Division of Air Pollution Control Response to Comments

Draft Regional Haze State Implementation Plan for the Second Implementation Period – Federal Land Manager (FLM) Consultation Period

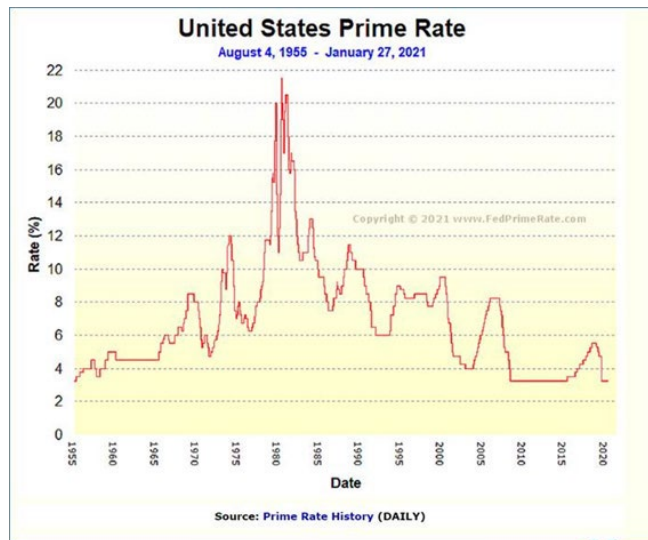
Comment 16: “We identified several issues with the source-specific four-factor analyses in Ohio’s plan that we expect will not be unique to Ohio. It is our hope that EPA will ensure that there is consistency across the country in their application.

- The interest rate used to annualize the capital costs of control equipment
 - Section 1, Chapter 2 of the EPA Control Cost Manual (7th ed.) says on page 15 “For permit applications, if firm-specific nominal interest rates are not available, then the bank prime rate can be an appropriate estimate for interest rates”

- Over the past 10 years the bank prime rate has hovered around 3% except for a brief spike to less than 6%.
- The analysis for Avon Lake references Office of Management and Budget (OMB) circular A-4 when using 7%.

- The 7% figure in Circular A-4 is actually a citation from a different document - Circular A-94 - dated 1992. The 7% figure was realistic relative to 1992 as you can see in the graph, but not in 2021.

Response 16: The four-factor analyses have been revised to use an interest rate of 3.25% unless justification for another firm-specific rate has been provided. Likewise, standard control equipment life, control efficiencies and average
